UNITED STATES PATENT AND TRADEMARK OFFICE

APPLICATION NO.	FILING DATE	FIRST NAMED INVENTOR	ATTORNEY DOCKET NO.	CONFIRMATION NO.
10/589,792	10/05/2006	Karlheinz Bing	BING ET AL. - 9 PCT	8699
25889	7590	04/14/2009		
COLLARD & ROE, P.C. 1077 NORTHERN BOULEVARD ROSLYN, NY 11576			EXAMINER NGUYEN, HUNG Q	
			ART UNIT	PAPER NUMBER
			3741	
			MAIL DATE	DELIVERY MODE
			04/14/2009	PAPER

Office Action Summary	Application No. 10/589,792	Applicant(s) BING ET AL.	
	Examiner HUNG Q. NGUYEN	Art Unit 3741

DETAILED ACTION

FIG. 4

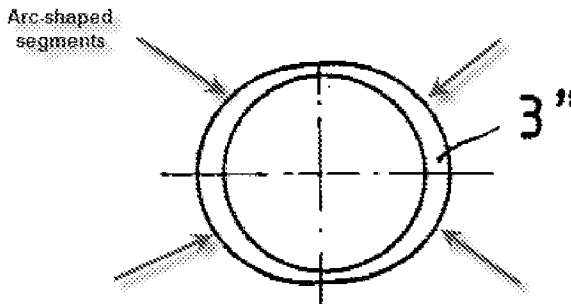
13. Regarding claim 4, Kodama / Sunada disclose the cylinder sleeve as essentially claimed except for an outer contour that consists, in cross section, of four arc-shaped segments that are approximately the same size.

Gobbels teaches that is it conventional in the art to provide a cylinder sleeve (see figure below) comprising an outer contour that consists, in cross-section, of four arc-shaped segments that approximately the same size.

Thus, it would have been obvious to one having ordinary skill in the art at the time the invention was made to modify the cylinder sleeve, as suggested and taught Kodama / Sunada, to incorporate a cylinder sleeve having an outer contour that consist, in cross section, of four arc-shaped segments that are approximately the same size, as suggested by Gobbels, for the purpose of preventing the occurrence of distortions during casting or engine operation (col. 1, lines 54-56).
